Recommended Amendments to the 2024 International Fire Code

North Central Texas Council of Governments Region

**FIGURE D103.6
FIRE LANE SIGNS**

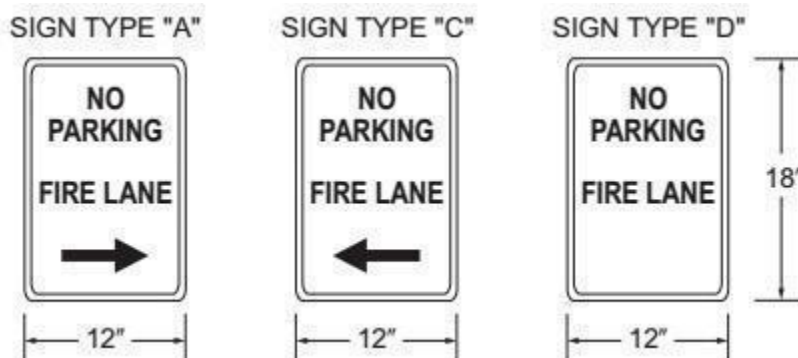
****Section D103.6; change to read as follows:**

D103.6 Signs. Marking. Striping, signs, or other markings, when approved by the *fire code official*, shall be provided for fire apparatus access roads to identify such roads or prohibit the obstruction thereof. Striping, signs and other markings shall be maintained in a clean and legible condition at all times and be replaced or repaired when necessary to provide adequate visibility.

(1) Striping – Fire apparatus access roads shall be continuously marked by painted lines of red traffic paint six inches (6”) in width to show the boundaries of the lane. The words “NO PARKING FIRE LANE” or “FIRE LANE NO PARKING” shall appear in four inch (4”) white letters at 25 feet intervals on the red border markings along both sides of the fire lanes. Where a curb is available, the striping shall be on the vertical face of the curb.

(2) Signs – Signs shall read “NO PARKING FIRE LANE” or “FIRE LANE NO PARKING” and shall be 12” wide and 18” high (See Figure D103.6). Signs shall have red letters on a white reflective background, using not less than 2” lettering. Signs shall be permanently affixed to a stationary post and the bottom of the sign shall be six feet, six inches (6’6”) above finished grade. Signs shall be spaced not more than fifty feet (50’) apart along both sides of the fire lane. Signs may be installed on permanent buildings or walls or as approved by the Fire Chief.

~~Where required by the fire code official, fire apparatus access roads shall be marked with permanent “NO PARKING FIRE LANE” signs complying with Figure D103.6, or other approved method. Signs shall have a minimum dimension of 12 inches (305 mm) wide by 18 inches (457 mm) high and have red letters on a white reflective background. Signs shall be posted on one or both sides of the fire apparatus road as required by Section D103.6.1 or D103.6.2.~~

(Reason: Reflects current markings for apparatus access roadways as indicated in the recommended amendment to Section 503.3)
